Proposed pull out door would have following modifications to "2. Existing pull out door" in Existing drawings:

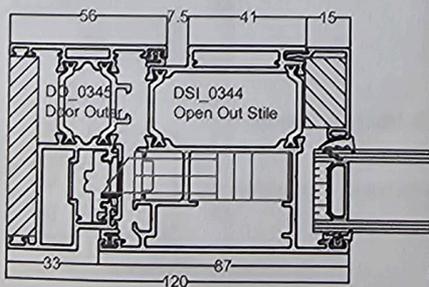
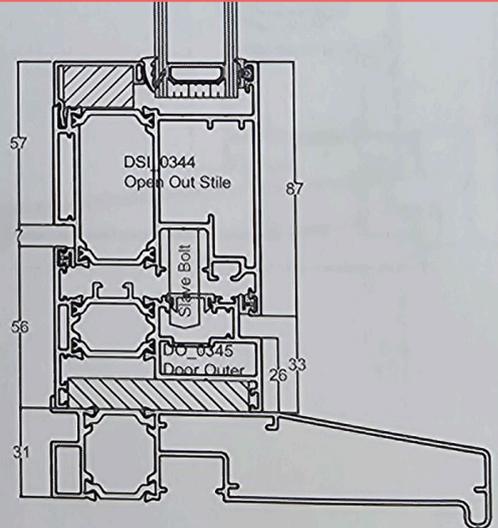
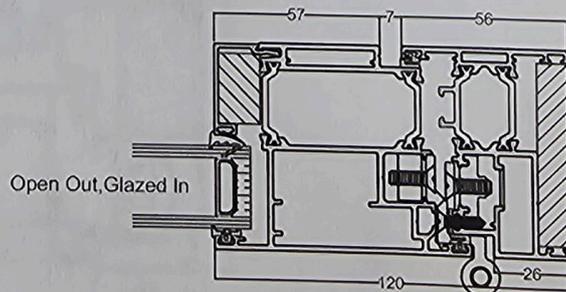
- One single glass pane instead of two separated panes
- Double-glazed glass instead of single-glazing
- Black frame instead of white frame
- Aluminium frame instead of timber frame
